APICAL INDUSTRIES, INC.
dba DART AEROSPACE

ENGINEERING CHANGE NOTICE NO.

DWG NO. 647.7700

DWG TITLE: STRUT ASSY

05397

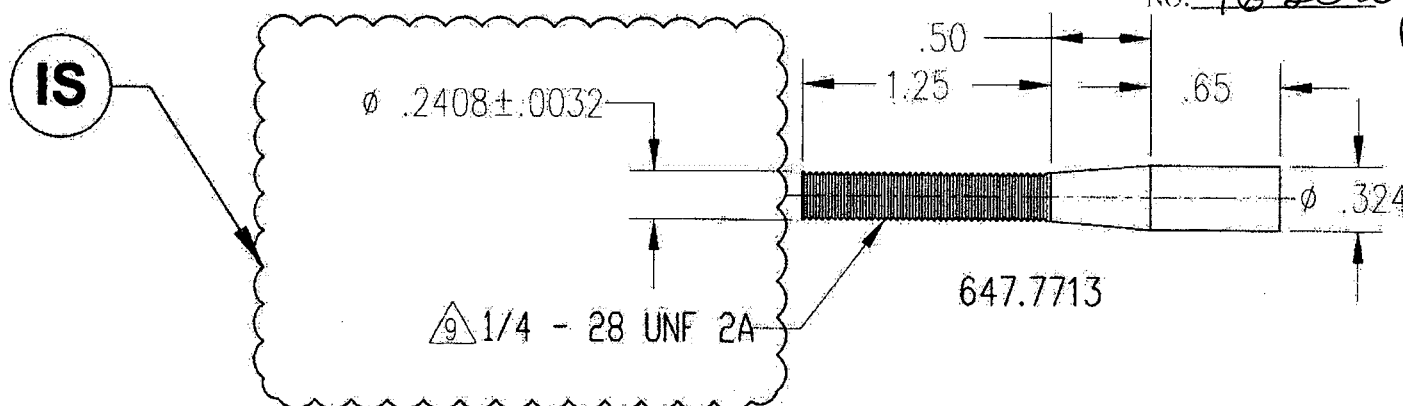
REASON: REVISED DIMENSION

SHEET 2, ZONE D4 IS:

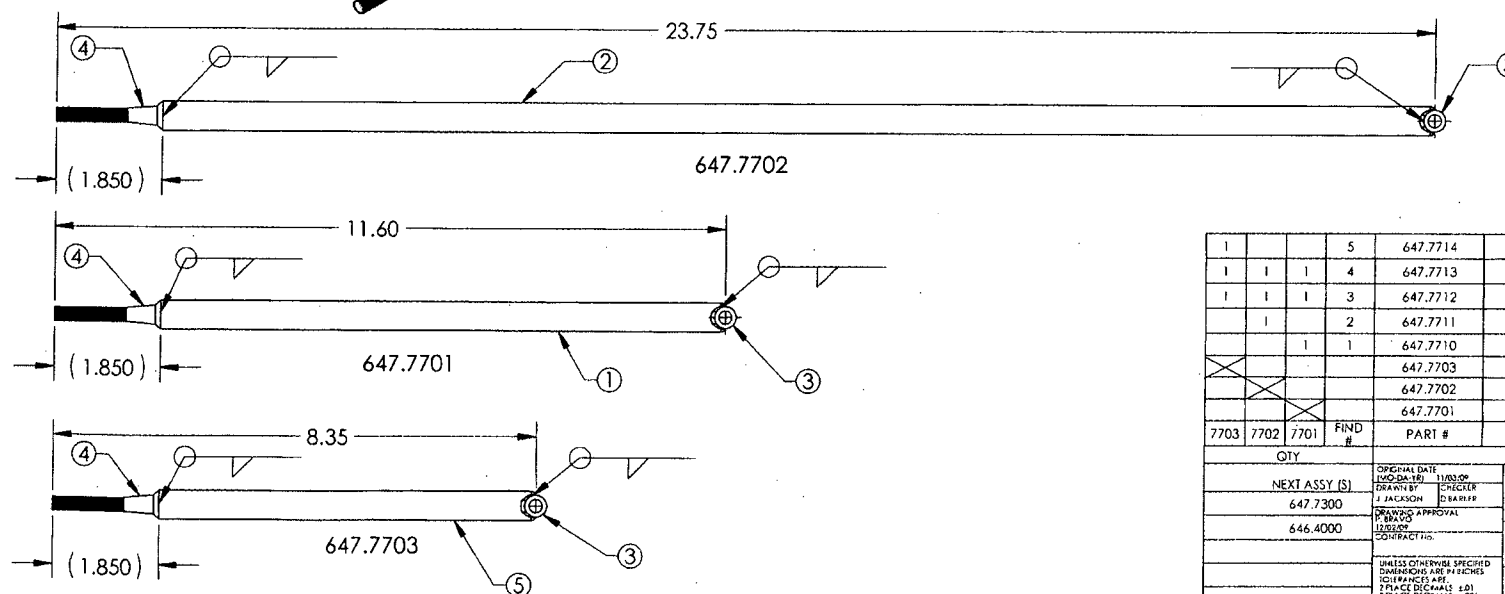
REASON: REVISED FINISH CALLOUT AS PER ECR 15-209

SHEET 1, NOTES IS:

- 1 MATERIAL: 4130 STEEL PER AMS-T-6736, .50" OD, .083" WALL THK.
- 2 MATERIAL: 4130 STEEL PER AMS-T-6736, .375" OD, .075" WALL THK.
- 3 MATERIAL: 4130 STEEL PER AMS-T-6736, .324" OD.
- 4 FINISH: PRIME IAW MIL-P-2337J TYPE I CLASS N: 1-2 MIL MAX
5. DEBURR AND BREAK ALL SHARP EDGES
6. IDENTIFY IAW MPP-120.
- 7 WELD IAW MIL-STD-2219. TIG WELD WITH FILLER ROD
- 8 FINISH: CAD PLATE IAW QQ-P-416F CLASS I TYPE II
- 9 MASK THREAD PRIOR TO FINISH
